Westinghouse Electric Company
Hematite Facility
3300 State Road P
Festus MO 63028
U.S.A.

Attachment: WEC Hematite Environmental Monitoring Plan (PO-EM-001, Rev. 1)

Subject: Response to NRC Request for Additional Information (TAC No. L52641)

NRC RAIs regarding EMP Revision 0 and Westinghouse responses with references to EMP Revision 1 (attachment):

Figure 5-3 Air Flow Direction Vector Histogram

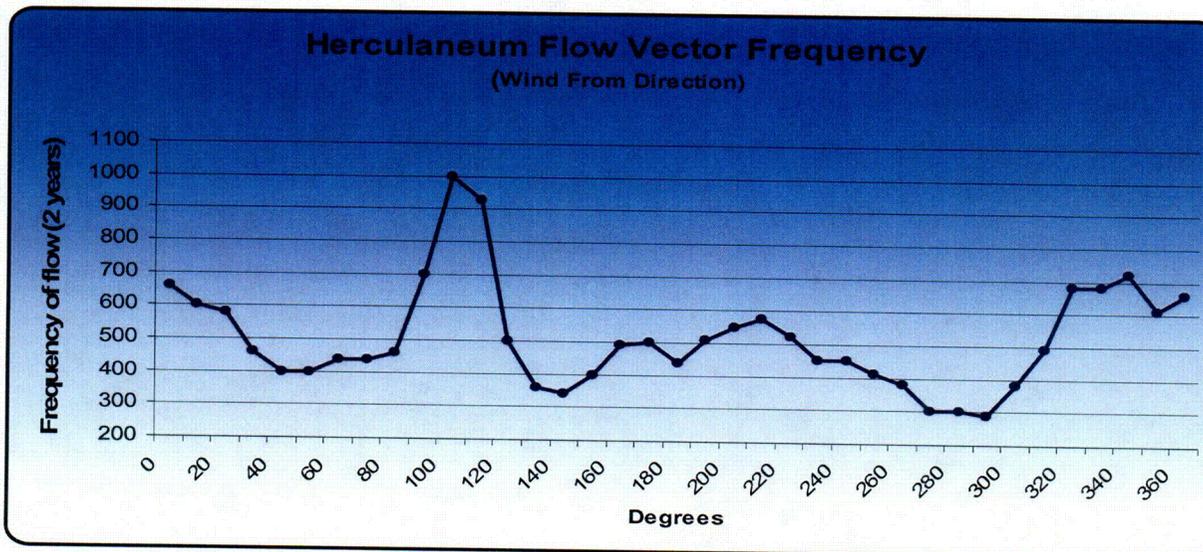
18. *Page 6-12, last paragraph: Reference the source of the predominant wind direction. Explain why the words "should be" are used versus "will be."*

This paragraph has been revised because the fourth air sampler has been established. Both sets of wind data in the EMP show that one of the more predominant wind directions is to the northwest.

Figure 6-3 Air and Soil and Vegetation Sample Locations

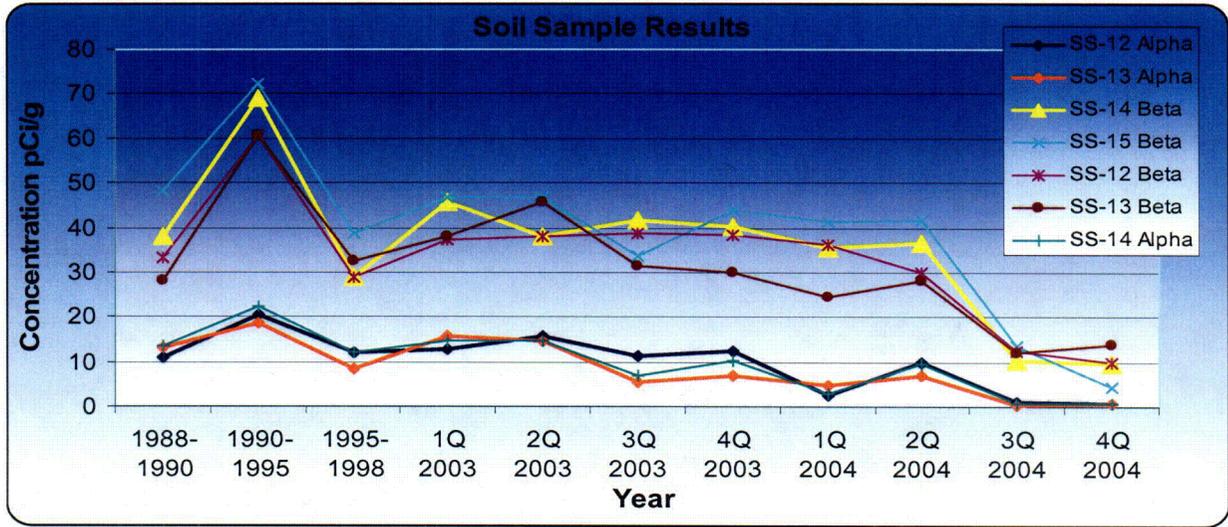
15. *Page 6-11: Provide justification for placement of the Hematite site perimeter air samplers. An acceptable methodology would consider such factors as the site's prevailing wind direction, and the distance to local population centers.*

16. *Page 6-11 and page 6-12: Justify the applicability of regional meteorological data to the Hematite site with due consideration of local terrain effects, and then justify the correct placement of the perimeter air samplers.*

The EMP references two sets of meteorological data that contradict each other. Due to the lack of on site data and the contradiction of the other data, section 5.3.1, EMP rev. 1, last sentence states, "Based on the directional variability, the sampling program has been designed to provide 360 degree coverage around the main plant areas." Four permanent samplers are set up at the site boundary. Two more perimeter samplers and additional temporary work control samplers will be used during building demolition and soil remediation. The location of these temporary work control samplers will change according to daily wind direction and operations. Significant changes in the wind direction during the day will also change the location of the temporary air samplers.

Figure 6-7 Site Dam and Composite Collection System Diagram

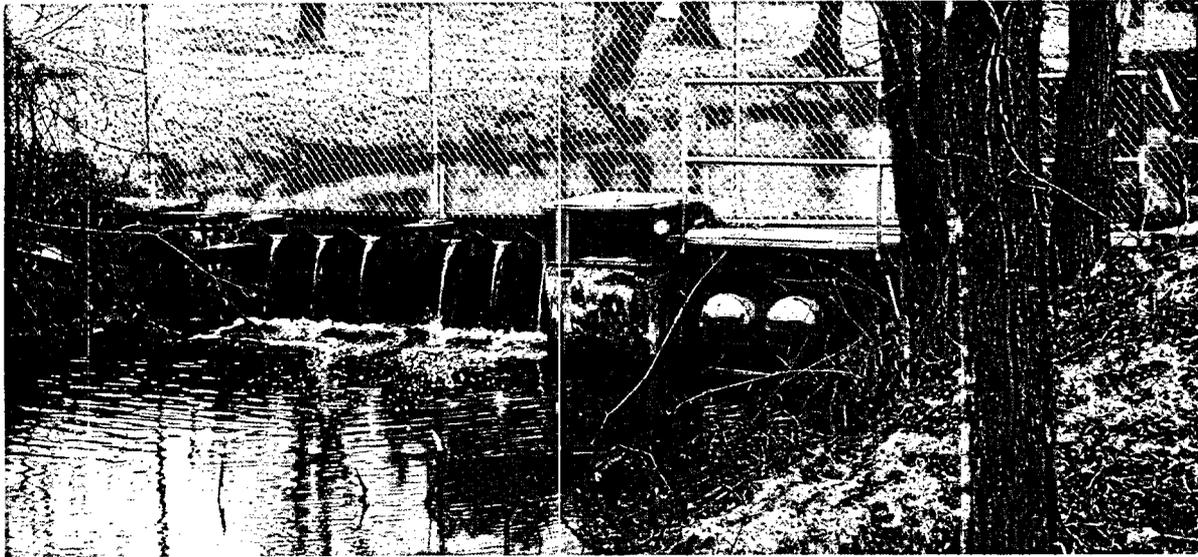
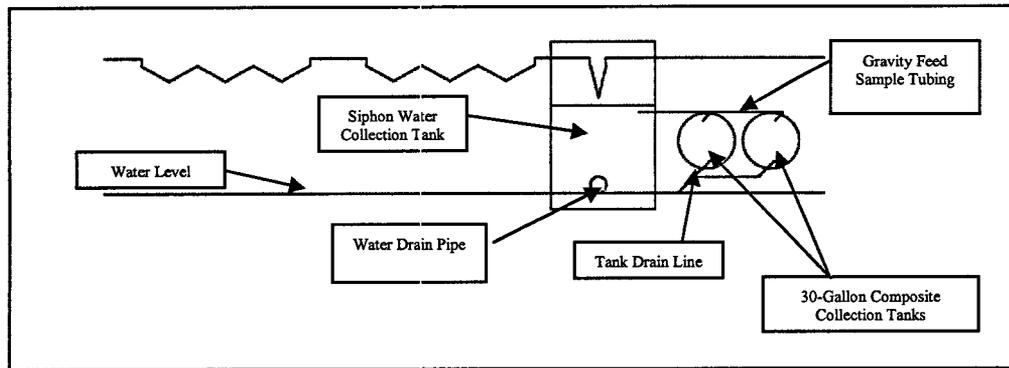
27. *Page 6-21, Section 6.4.3: Weir Sampling. Please show in a separate figure, or sketch the relative locations of, the siphon tank, the small 30 V-notch weir feeding the siphon tank, the siphon tank and the site dam with its six (6) 120 V-notch weirs. The figure or sketch may start from an upstream point and end at a downstream point of the system. Also, please explain the function of the two 30-gallon composite collection drums and their relationships to the weirs and the siphon tank system. The water flow system information is not clear from the descriptions.*

Westinghouse has included a diagram for the composite collection drums. The purpose of the drums is to collect a small fraction of the water in the siphon tank to make a composite sample over a one week period. Please refer to the EMP, Rev. 1, section 6.4.3, for this RAI.
